**INVITATION TO TENDER NO. PS20180920
PROVISION OF CONTRACTOR SERVICES FOR WASHROOM UPGRADES
AT 3214 W 10 AVE**

ADDENDUM NO. 2

RE: ARCHITECTURAL/MECHANICAL DRAWINGS & SPECIFICATIONS

PROJECT
ST. JAMES COMMUNITY SQUARE - WASHROOM UPGRADES

DRAWING
Phasing Diagram - LI

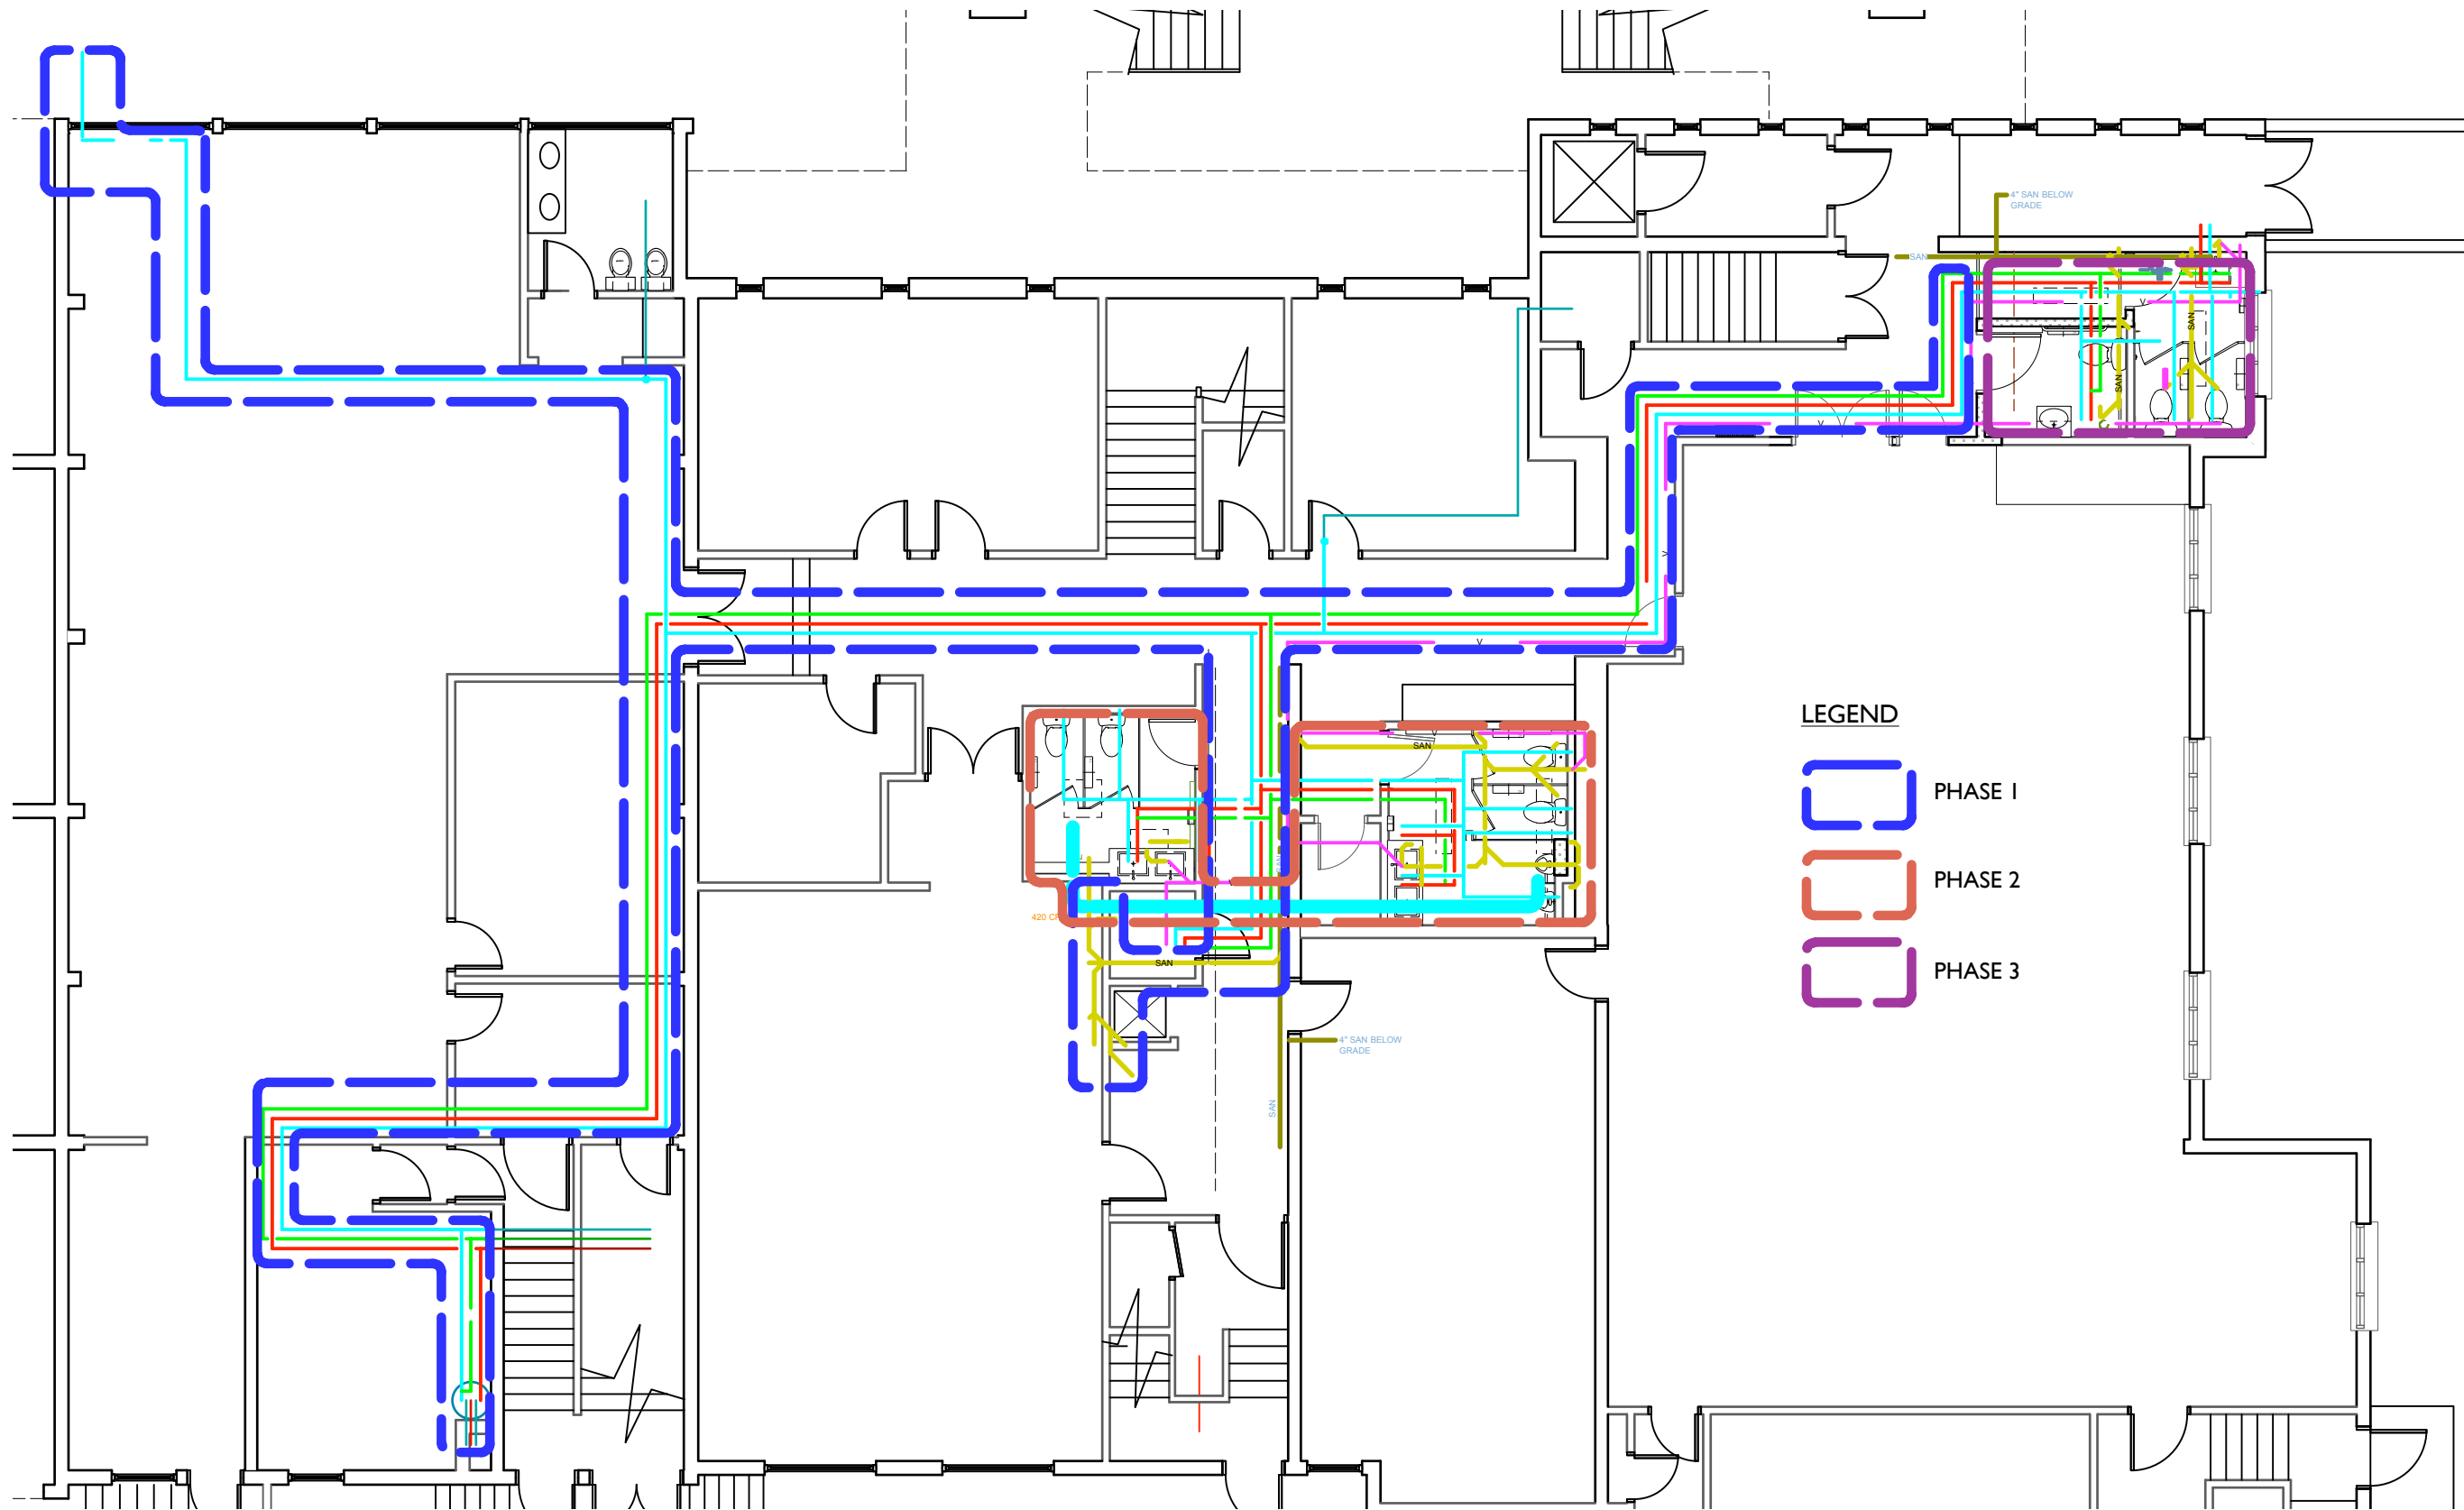
- .1 PHASING Refer ASK1-ASK2
- Phase 1 is to be delivered by Dec 2018. (Lower Level piping outside of washrooms to be part of Phase 1)
 - Phase 2 to follow by March 2019.
 - Phase 3 ‘separate price’ – if included as part of the work to the contractor, is to be included in the timeframe of Phase 2 – completion by March 2019.
 - **All water main connection work is to be part of Phase 1.** The sprinkler room/closet is located in the Daycare space. The Daycare may **not** be shut down at any point, therefore the piping work to be done on the inside of the building is required to happen after daycare hours or weekends.
 - **Working Hours of the Daycare are M-F from 7:00am to 6:00pm.**
- .2 Refer ASK3 Detail of for trenching at Lower Level. For locations refer to M201.

PROJECT NO.: 127b-040-18
DRAWING NO.: M201

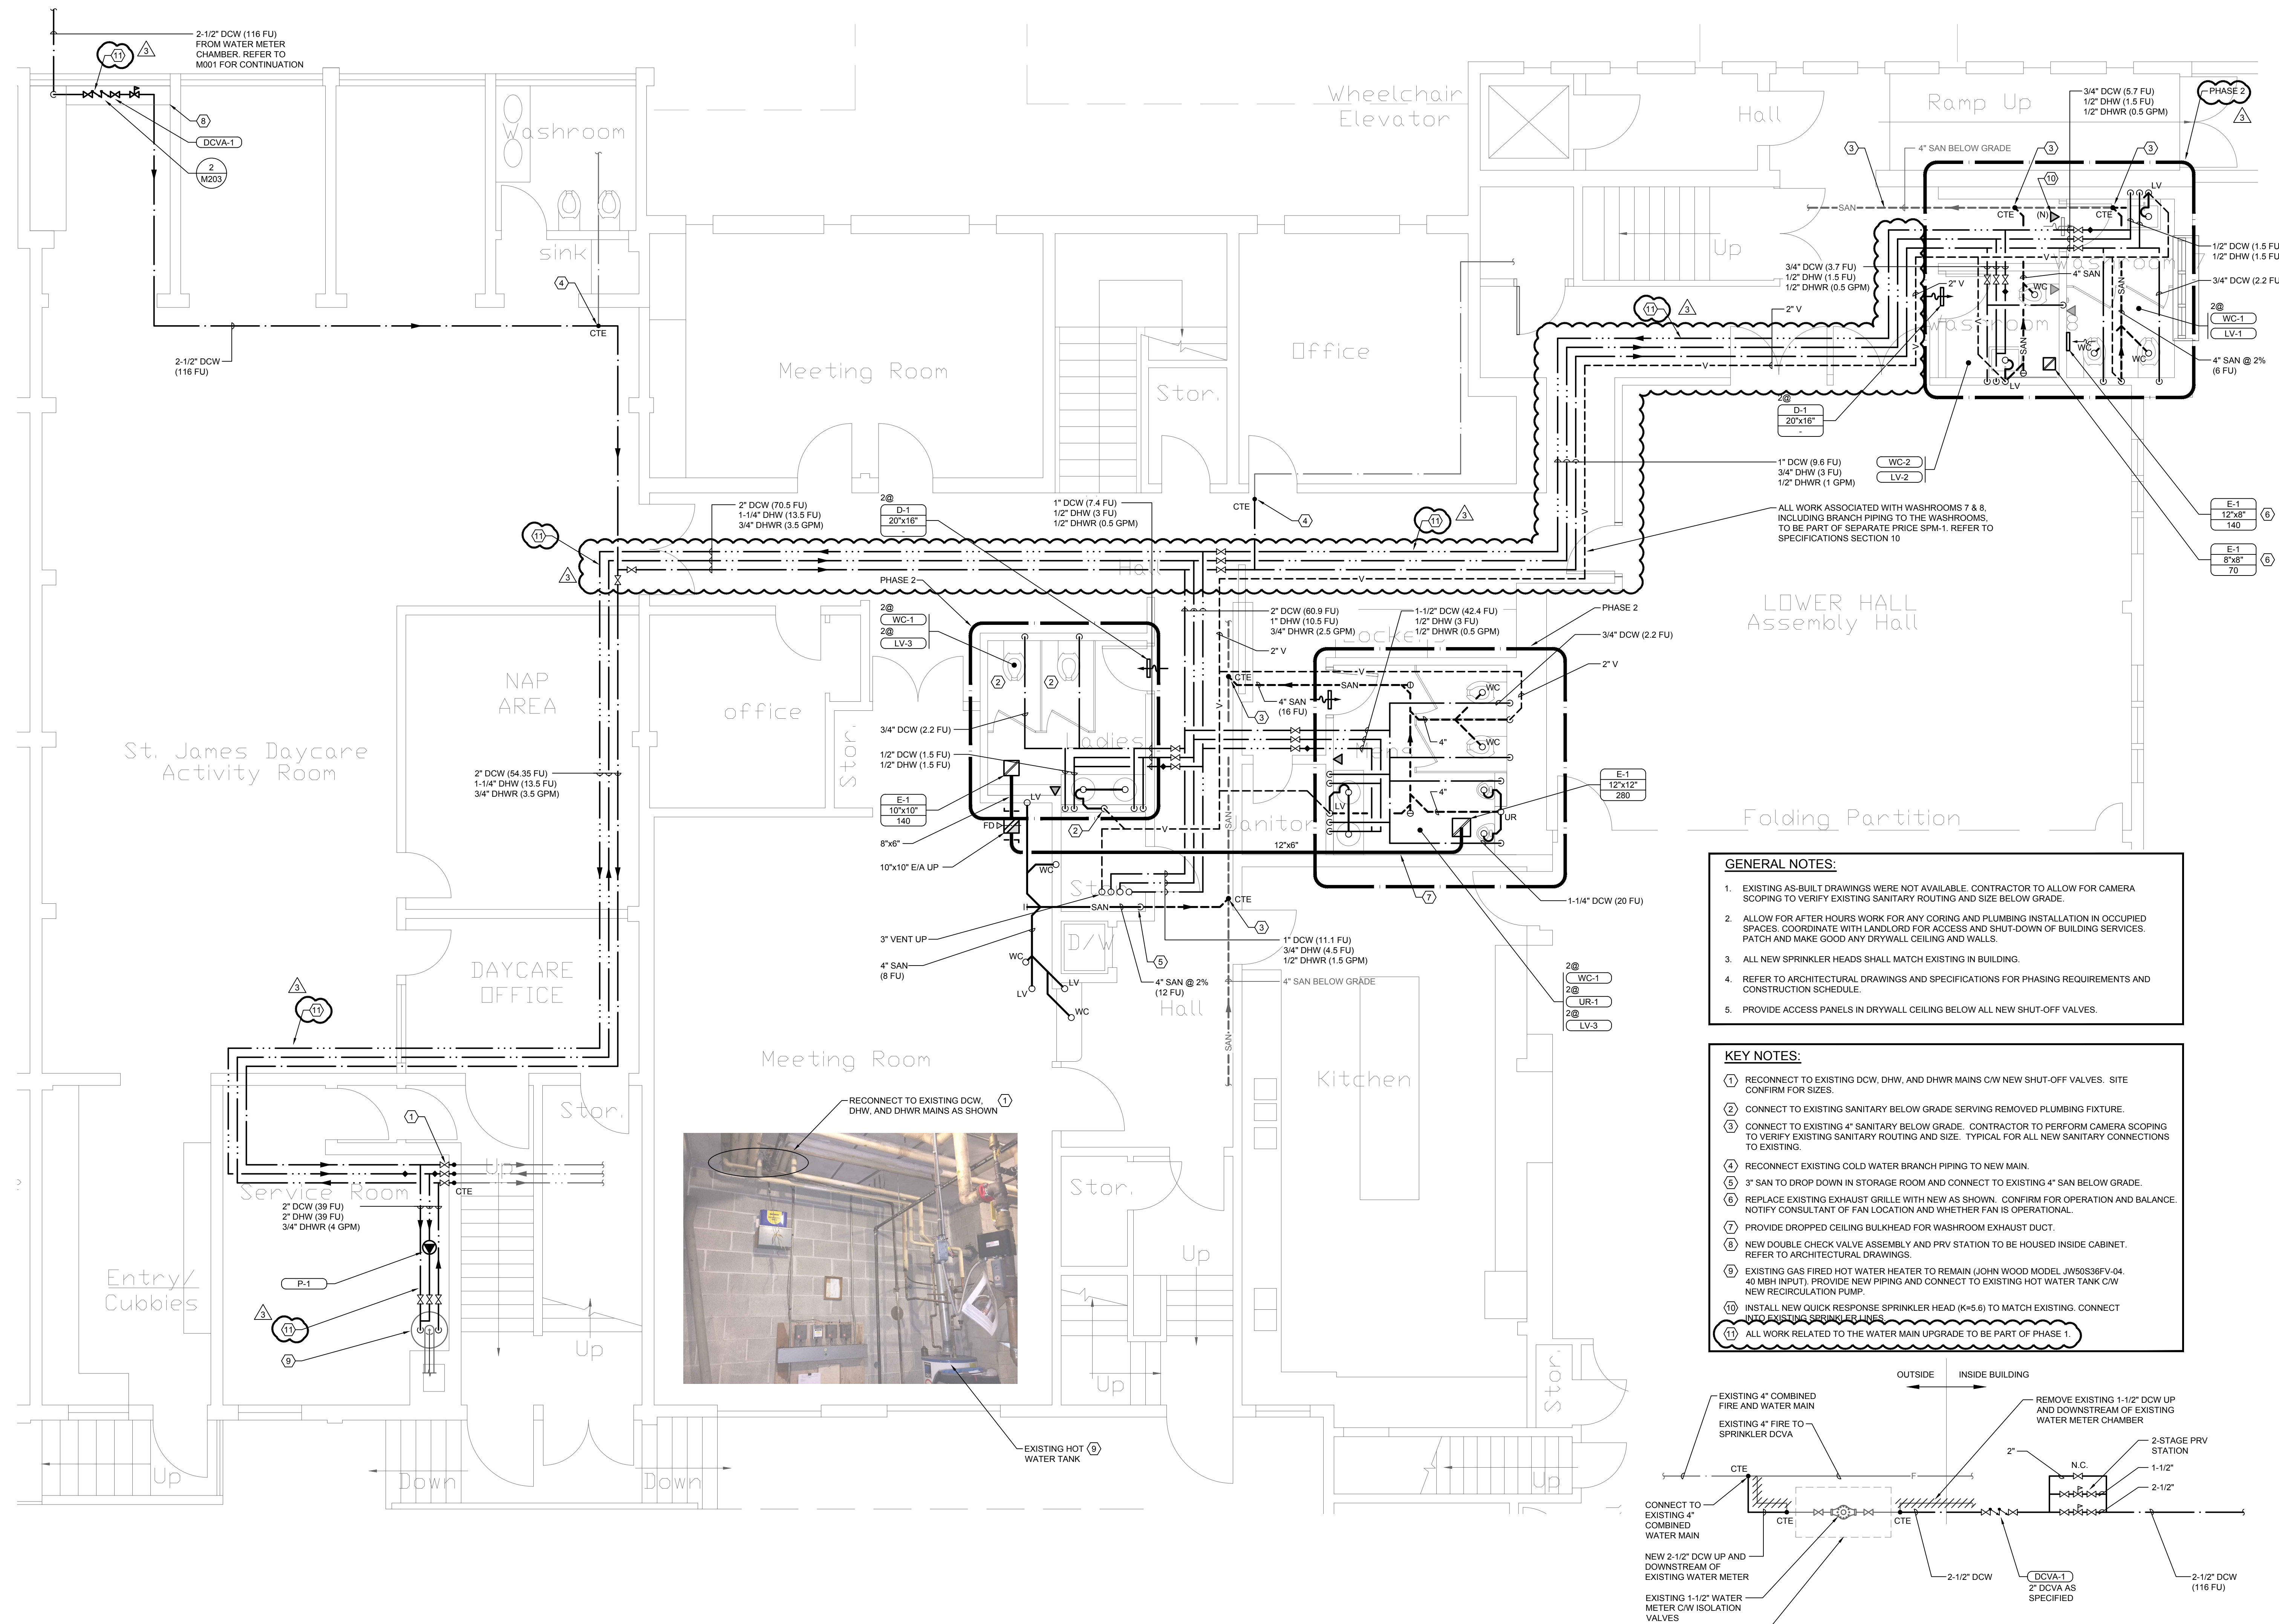
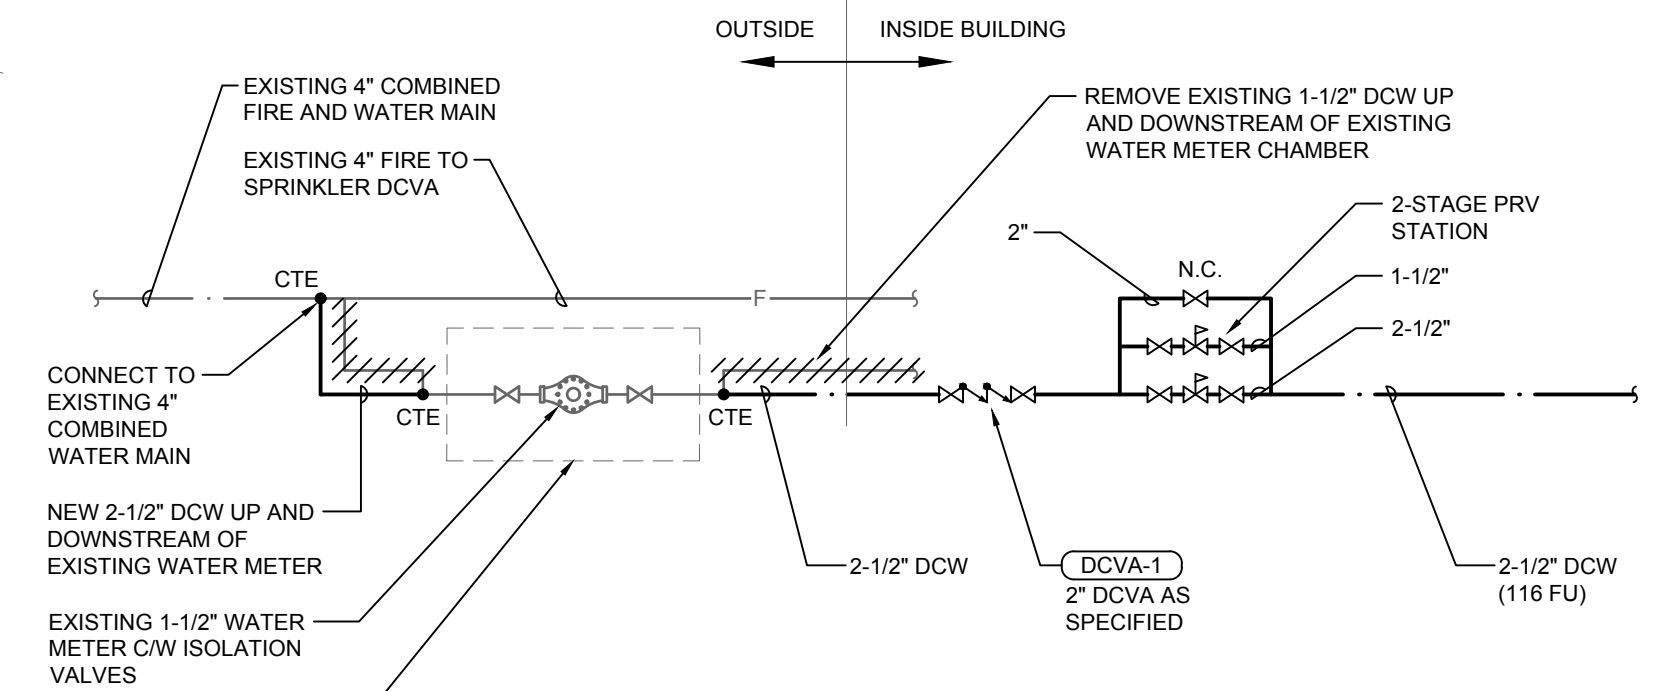
1.2 Drawing No.: M201 Lower Floor Plan – HVAC, Plumbing and Fire Protection

- .1 Drawing has been reissued as per attached. Revised areas have been clouded.
